# Access Compliance Report

## Public Rights-of-Way

Intersection ID: 26409	Main Street: KUYKENDALL_RD	Cross Street: PROVIDENCE_RD	Location: SE
ADA ID: 260709757AC7	Ramp Type: Perp	Initial Pass/Fail: Fail	Overall Compliance: No
Severity Score: 33.75			
Codes/Mitigation Info/Possible Solution		Field Measurements/Component Compliance

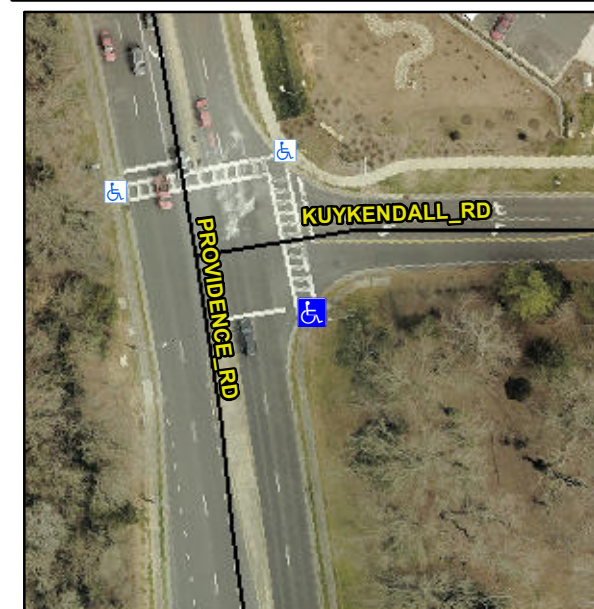
**Not Found, R304.5.1, R304.5.3**

Compliance	Description	Data	Compliance	Description	Data
N/A	Ramp Length (in)	81.0	Yes	Ramp Slope (%)	6.2
No	Ramp Width (in)	45.5	No	Ramp XSlope (%)	7.1
N/A	Flare Type LT	N/A	N/A	Flare Type RT	N/A
N/A	Flare Slope LT (%)	N/A	N/A	Flare Slope RT (%)	N/A
N/A	Flare Traversable LT?	N/A	N/A	Flare Traversable RT?	N/A
N/A	Landing Length (in)	N/A	N/A	DWS Provided?	N/A
N/A	Landing Width (in)	N/A	N/A	DWS Contrast?	N/A
N/A	Landing Slope (%)	N/A	N/A	DWS Length (in)	N/A
N/A	Landing X Slope (%)	N/A	N/A	DWS Full Width?	N/A
N/A	Landing Curb? (Y/N)	N/A	N/A	DWS Offset (in)	N/A
N/A	Shared Landing?	N/A			
N/A	Gutter Ponding?	N/A	N/A	Gutter Slope (%)	N/A
N/A	Gutter Lip Ht (in)	N/A	N/A	Gutter X Slope (%)	N/A
N/A	Painted X Walk1?	Yes	N/A	Painted X Walk2?	N/A
	X Walk 1 Direction	To N		X Walk 2 Direction	N/A
N/A	X Walk 1 Width (in)	90.0	N/A	X Walk 2 Width (in)	N/A
	X Walk 1 Slope (%)	1.2		X Walk 2 Slope (%)	N/A
	X Walk 1 X Slope (%)	6.5		X Walk 2 X Slope (%)	N/A

**Remove & Replace Entire Ramp.**
